Ashton Coal Project - Response to DLWC

Proposed Ashton Coal Project

RISK OF INFLOWS FROM ALLUVIUM
White Mining Limited
 Ashton Coal Project - Groundwater Hydrology
 Camberwell, New South Wales

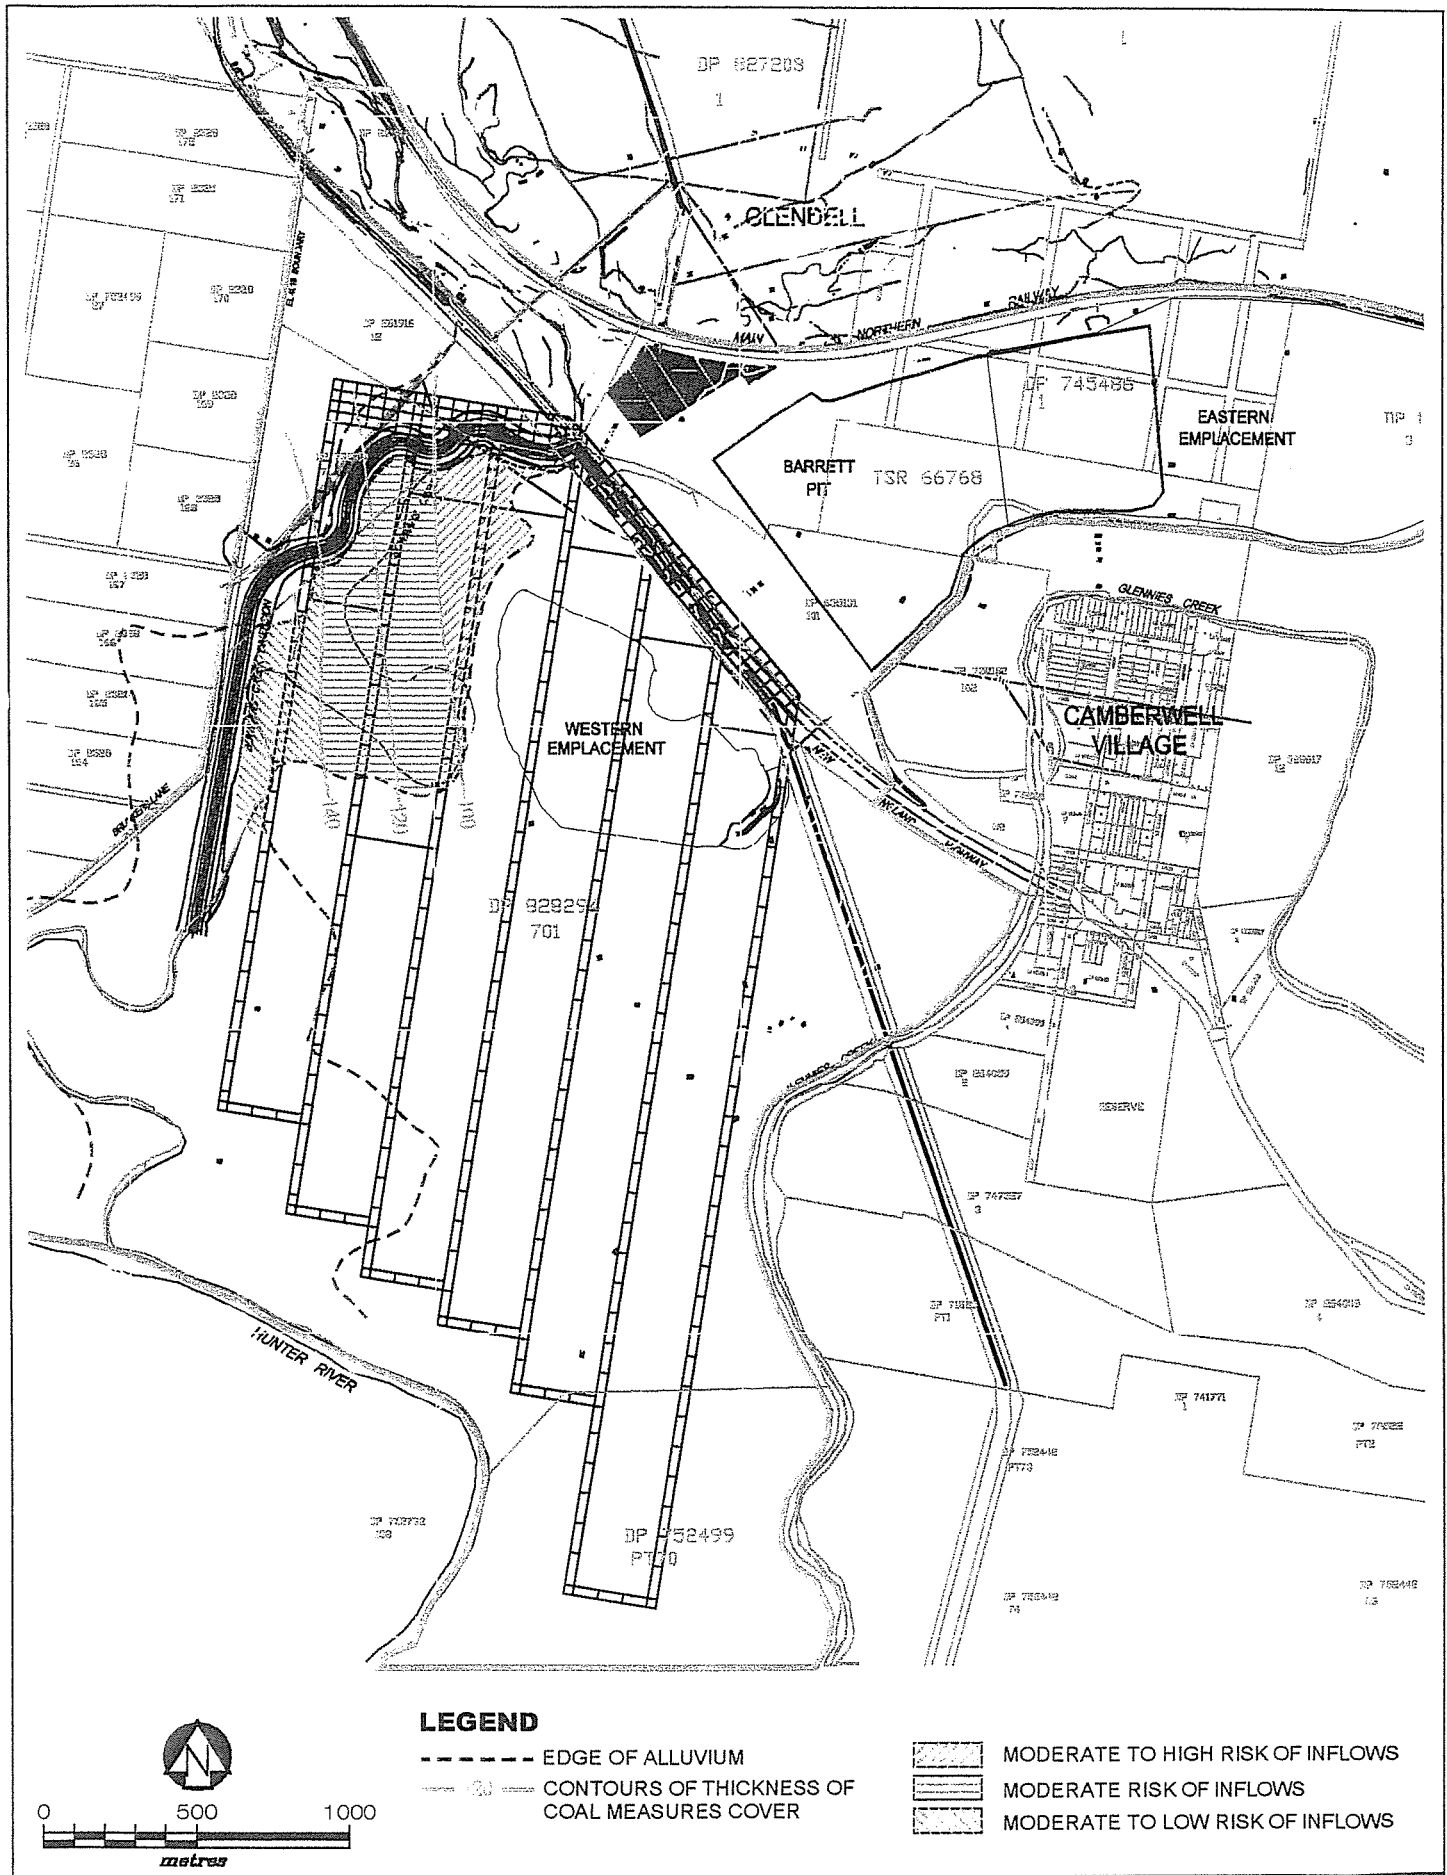
2.0 Demonstration that EIS predictions are based on 'worst case' scenarios with regard to fracture development in the underground workings

In section 6.0 **Appendix J** of the EIS, the inflows to the mine, or water loss from the alluvium was estimated assuming a worst case scenario that "open fractures will connect the underground mine to surface fracturing in Bowmans Creek alluvium which could drain the shallow groundwater in the alluvium". This assumption was based on:

- i) An initial assessment (pre-EIS) of the risk of inflows from the surface based on the height of subsidence induced fracturing and the minimum thickness of coal measures cover to provide a protective barrier between the underground mine and Bowmans Creek and the adjoining alluvial aquifer. This assessment used methods described in Singh and Kendowski (1983), which are based on the following empirically derived relationship for predicting the height of fracturing ($h = 56 \times t^{0.5}$) developed from back analysis of inflows at many mines in the northern hemisphere. The minimum

total thickness of cover, or protective barrier for a 2.1m extraction in the Pikes Gully Seam at Ashton, ranges from about 110m to about 125m, allowing for about 80m fracture height, 15m depth of surface fracturing and between 15 and 30m of aquiclude. . The attached drawing of the thickness of coal measures cover under the Bowmans Creek alluvium indicates, there is a moderate to high risk of inflows from the alluvium and stream channel (ie cover thickness to base of alluvium < 110m), at the northern end of longwall panels 4 and 5. Panel 6 has a moderate to low risk of inflows due to the greater thickness of coal measures cover (>140m).

Back analysis of the Cumnock and Wambo experience suggests that the overseas relationship used to estimate the height of fracturing ($56 \times t^{0.5}$) should be modified to about $40 \times t^{0.5}$ for the Hunter Valley. Applying this to Ashton using, reduces the minimum cover thickness from 110m to 125m down to 80m to 105m, which suggests a lower risk of inflows, except for portions of the northern end of panel 4 and 5.
